Approved elevation at left with inset photo showing departure from plans

2 PROPOSED WEST ELEVATION REVISION
SCALE: 1/4" = 1'-0"

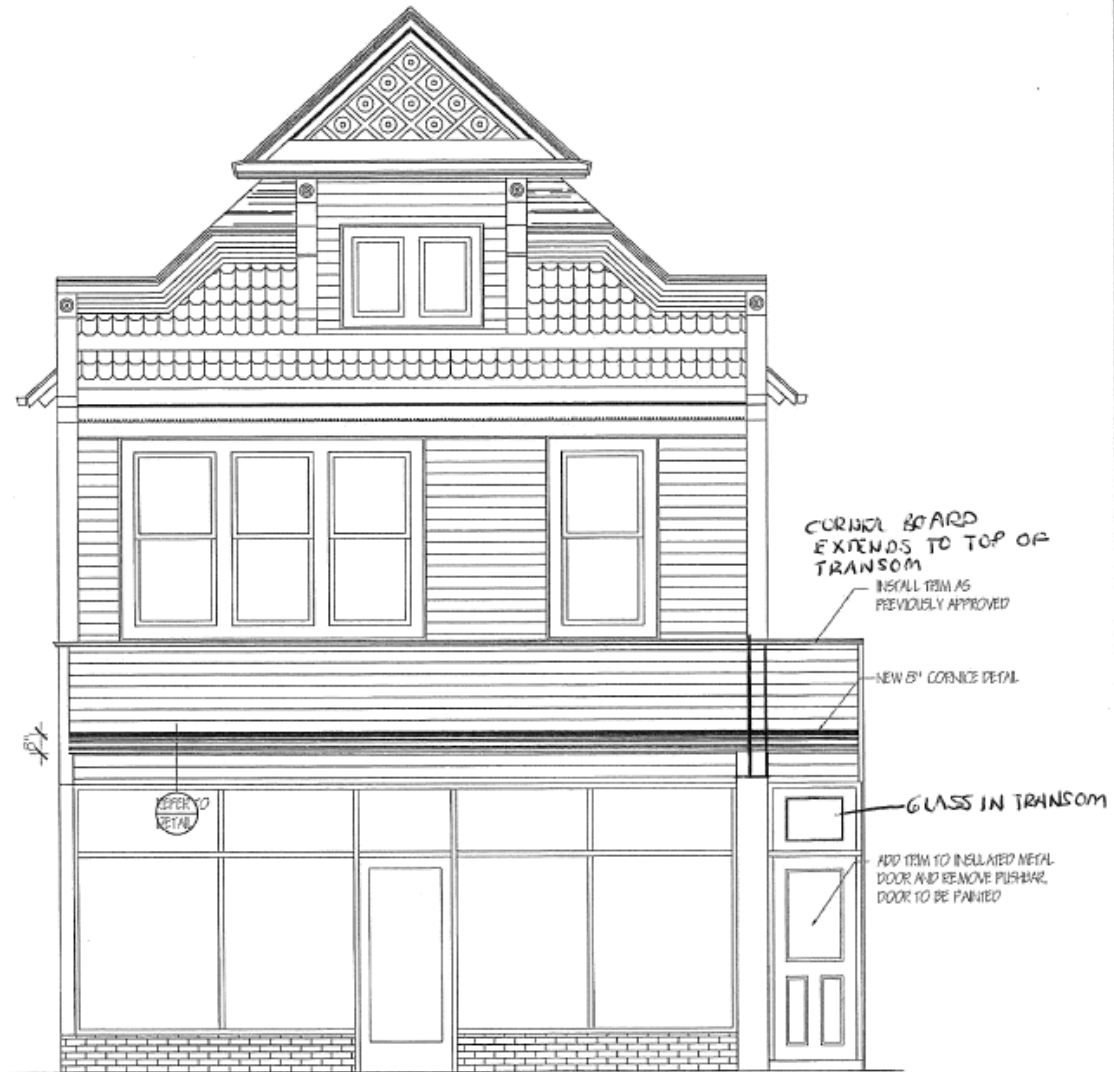
The drawing shows what the façade should look like in terms of trim detail, door styles. It was approved by the HPC on September 11, 2017. The recessed entry in the drawing was not built as drawn but flush with the front of the building. Arrows point to other areas that will be brought into conformity with drawing.

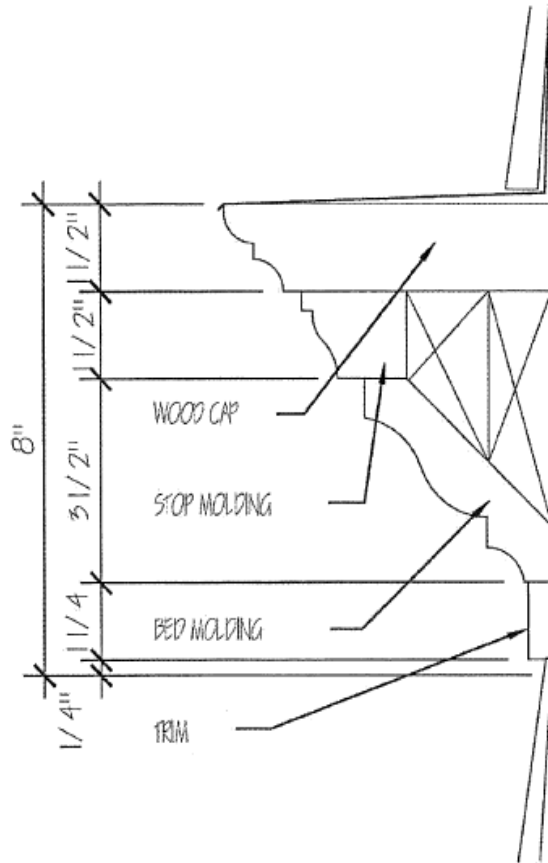
Mr. Salinas wanted to remove the recessed entrance to allow for more interior retail floor space.

This is how the storefront will look.

Cornice will be added to match this design
